**STAFF REPORT - DESIGN REVIEW E
FINDINGS AND RECOMMENDATION**

FILE NUMBER: **DRE/LL/SUR/TR/VAR 17-26000242 - Good Samaritan**

PROPOSAL: Type III Design Review E for the construction of a 26,265 square-foot building expansion to the existing 30,463 square-foot Good Samaritan's skilled care facility. The proposal includes modifications and improvements to the existing/associated parking area and landscaping as well as a lot line adjustment.

Proposed Lot Line Adjustment

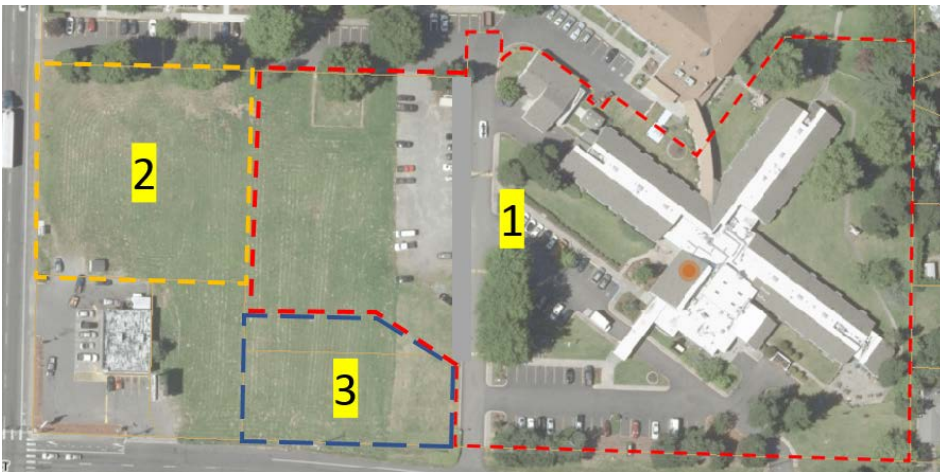
The property line between Lot 1 and Lot 2 is shifting approximately 204 feet to the west, while the property line between Lot 2 and 3 is shifting approximately 45 feet to the north. The proposal meets the submittal requirements of Section 11.0900, and no new lots are being created. Therefore, the proposal complies with the criteria stated in Section 6.0100 and 3.0110 - Definition of Lot Line Adjustment/Consolidation.

The consolidated lots meet the minimum lot size, dimensions, and street frontage requirements for lots in the MC land use district. A split zoned lot (proposed Lot 1) is created (CMF/MC). Configuration of the newly created lots will not result in foreseeable difficulty in securing building permits. A final map and deed descriptions per 6.0111 shall still be required.

These standards are met with Condition of Approval #9a - #9c.

Portland Water Conduit

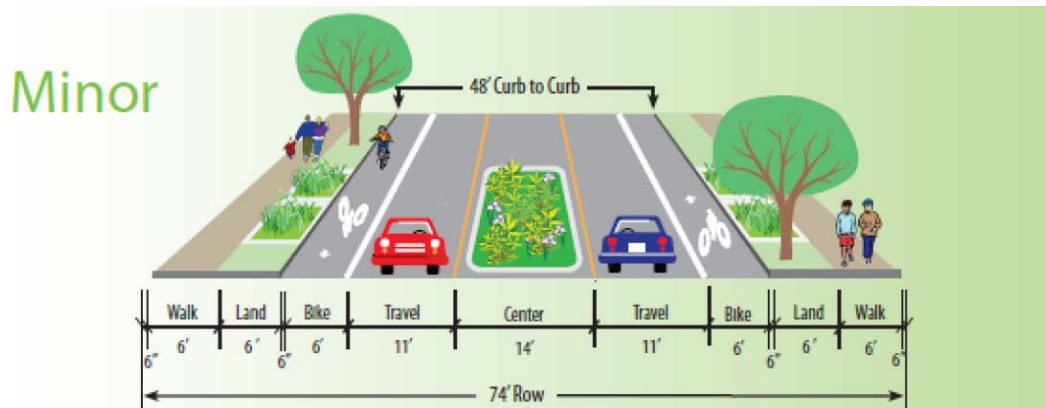
There is a City of Portland water conduit in NE Division Street adjacent to the property. A utility protection plan, stamped by a licensed Oregon Engineer shall be submitted with the construction plan submittal. Portland Water Bureau's Utility Protection Guidelines can be found at the following link: www.PortlandOregon.gov/Water/article/415225.

13. If the area of disturbance exceeds 1 acre, a NPDES 1200-C permit shall be obtained from the Oregon Department of Environmental Quality (DEQ).
14. To ensure protection for the City of Portland water conduit in NE Division Street, a utility protection plan, stamped by a licensed Oregon Engineer, shall be submitted with the construction plan submittal.
